UNITED STATES PATENT AND TRADEMARK OFFICE

APPLICATION NO.	FILING DATE	FIRST NAMED INVENTOR	ATTORNEY DOCKET NO.	CONFIRMATION NO.
10/646,611	08/22/2003	Guy Simon Dawson	37261P087	9810

Office Action Summary	Application No.	Applicant(s)	
	10/646,611	DAWSON, GUY SIMON	
	Examiner	Art Unit	
	Vinh T. Luong	3682

ATTACHMENT

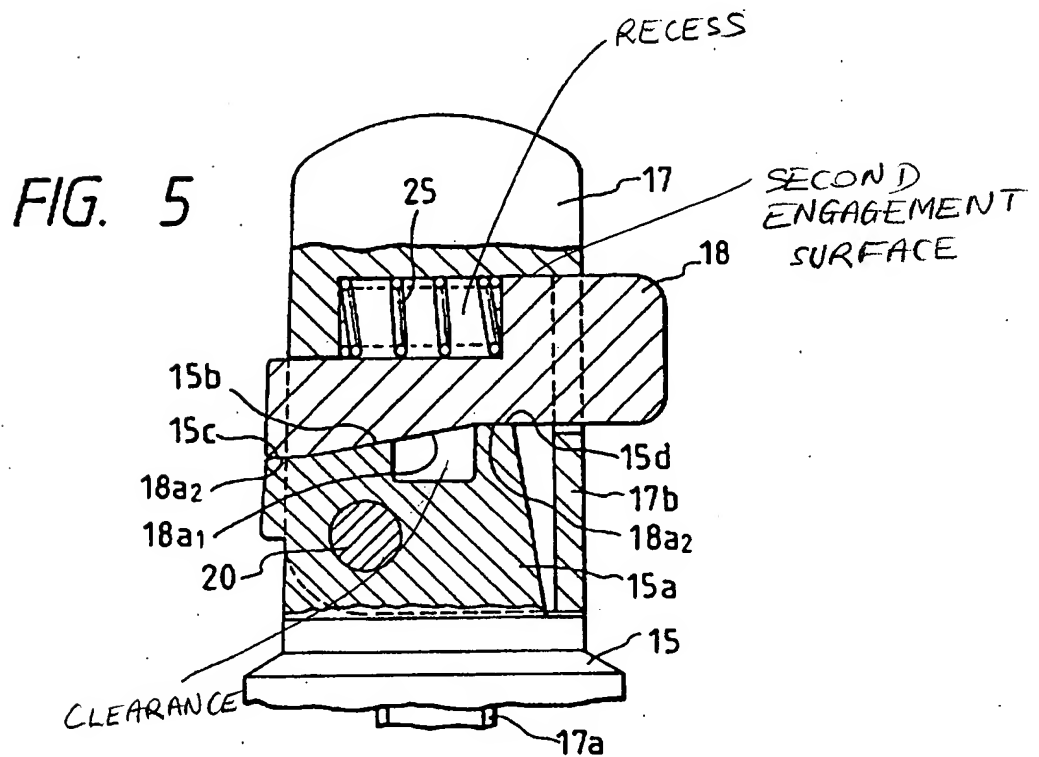
Regarding claim 2, the push button 18 includes a head 18c slidably located in a recess (see Attachment) in the handle member 17.

Regarding claim 3, the peripheral shape of the recess (Att.) substantially corresponds to a peripheral shape of the button 18.

Regarding claim 13, the recess (Att.) includes a contact surface (Att.), which is contacted by the head 18c when the locking member 18 is in the release position.

Regarding claim 18, the lip 18a₂ projects from the blocking portion 18b, 18a₂ (Fig. 4), 18f (Fig. 8A-8C), etc. The engagement surface (Att., Fig. 4) is formed by a wall in the handle member 17. The wall (Att.) further forms a second engagement surface (Att., Fig. 5). The blocking portion 18b, 18a₂ (Fig. 4), 18f (Fig. 8A-8C), etc. of the locking member 18 is located between second engagement surface (Att., Fig. 5) and a surface 15b of the pivot base 15 to create the blocking action.

FIG. 8A

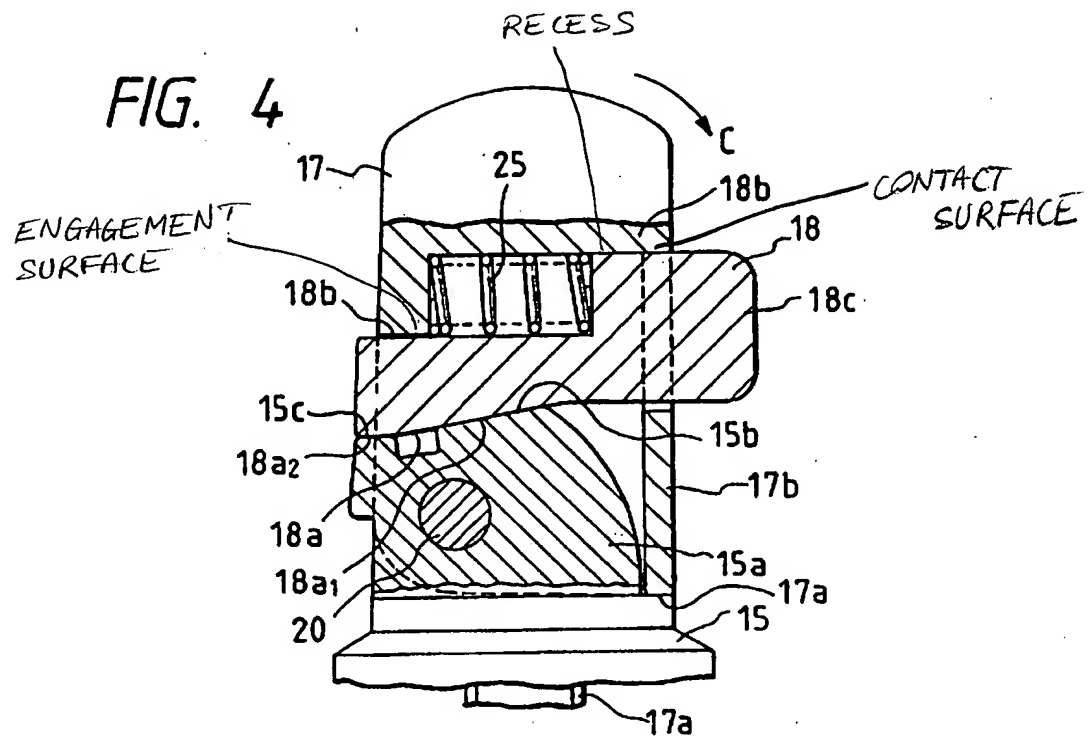
Regarding claim 8, the stop 18a₂ is a lip 18a₂ projecting from the locking member 25 and engaged with an engagement surface (at 18b in Fig. 4) of the handle member 17 when the handle 17 is in the first position (Fig. 8A).

Regarding claim 10, the locking member 18 includes a profiled portion 18a₁ (Fig. 5), 18e (Fig. 8C), etc. which provides a clearance (Att.) between the locking portion and the pivot base 15 when the locking member 18 is in the release position (Fig. 8C).

FIG. 8C

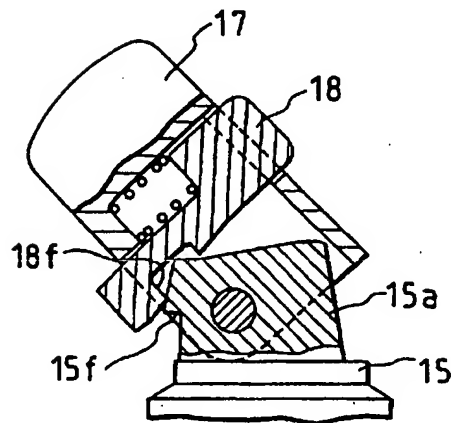
Regarding claim 11, the profiled portion 18a₁ (Fig. 5), 18e (Fig. 8C), etc. includes a contact surface 18a₁ (Fig. 5), 18e (Fig. 8C), which contacts a profiled surface 15b of the pivot base 15 during movement of the handle 17 between the first and second positions.
